Flight Procedures Cover Page	Task Action: FLIGHT CHECK	Task Type: IAP	Estimated Chart Date: 10/02/2025	APWS Task ID: FE0E2EFB848E4293824B877955C4BB79	APWS Project ID: 283E2EEC5D6047EFB44AE3FA26B77EA5
Procedure: RNAV (GPS) T RWY 8 AMDT 1 (SPECIAL)	Enroute: NO	Specialist: Nesbitt, Cole	Agreement Number:		
Airport ID: PAJN	Airport City: JUNEAU	State: AK			
Facility ID:	Facility Type:	Flight Inspection Remark Type: New FC Slot

Juneau, AK
(PAJN) Juneau Int'l
RNAV (GPS) T Rwy 8 (Special)

US Department of Transportation Federal Aviation Administration	FLIGHT PROCEDURES STANDARDS WAIVER	FLIGHT STANDARDS USE ONLY CONTROL NO:
1. Flight Procedure Identification: JUNEAU, AK (PAJN) JUNEAU INTL RNAV (GPS) T RWY 8 (SPECIAL)

RNAV (GPS) T RWY 8

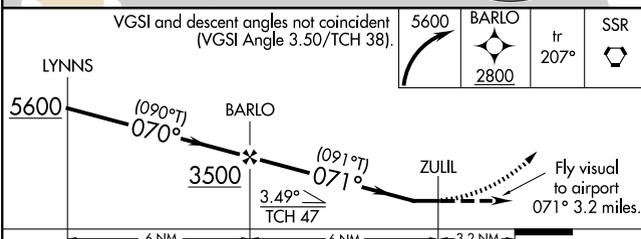
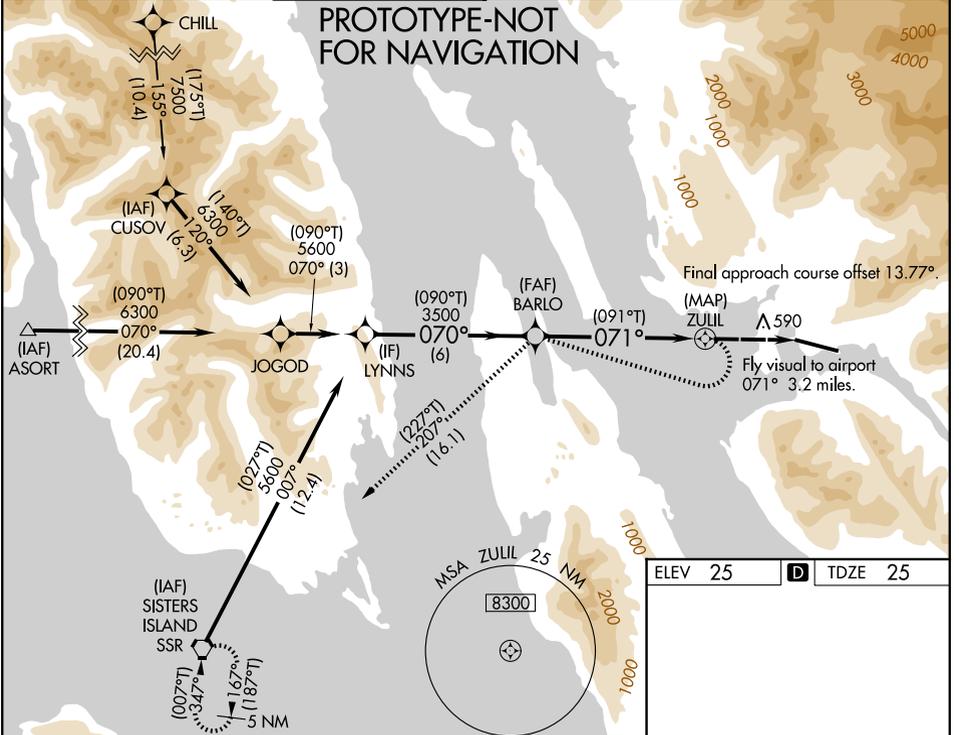
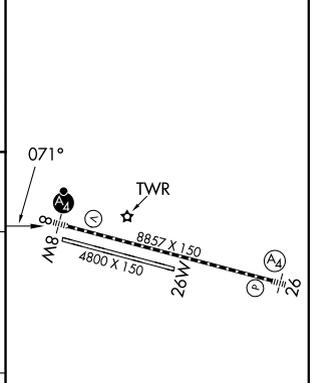
1. REMOVED NOTE: STRAIGHT-IN RWY 8 AT NIGHT, OPERATIONAL VGSI REQUIRED, REMAIN ON OR ABOVE VGSI GLIDEPATH UNTIL THRESHOLD.
2. ADDED NOTE: RWY 8 AT NIGHT, OPERATIONAL VGSI REQUIRED. UPON REACHING MDA, DO NOT DESCEND UNTIL ON OR ABOVE THE GLIDEPATH TO THRESHOLD.

1. CHART NOTE CHANGED FROM "WHEN JNU/PAJN ALTIMETER SETTING NOT RECEIVED, PROCEDURE NA" TO "WHEN LOCAL ALTIMETER SETTING NOT RECEIVED, PROCEDURE NA".

⚠ Circling NA north of Rwy 8-26. Rwy 8 helicopter visibility reduction below 1 SM NA. When JNU/PAJN altimeter setting not received, procedure NA. Circling NA at night. Use of this procedure requires specific authorization by FAA Flight Standards.

⚠ **1°C** Caution: Any go-around after passing MAP will not provide standard obstruction clearance. If lead-in lights are not visible at the MAP, execute missed approach. Procedure NA when winds exceed 30K from 300 to 360 degrees. For inop lead-in lights, increase all visibilities to 4 miles. Straight-in Rwy 8 at night, operational VGSI required, remain on or above VGSI glidepath until threshold.
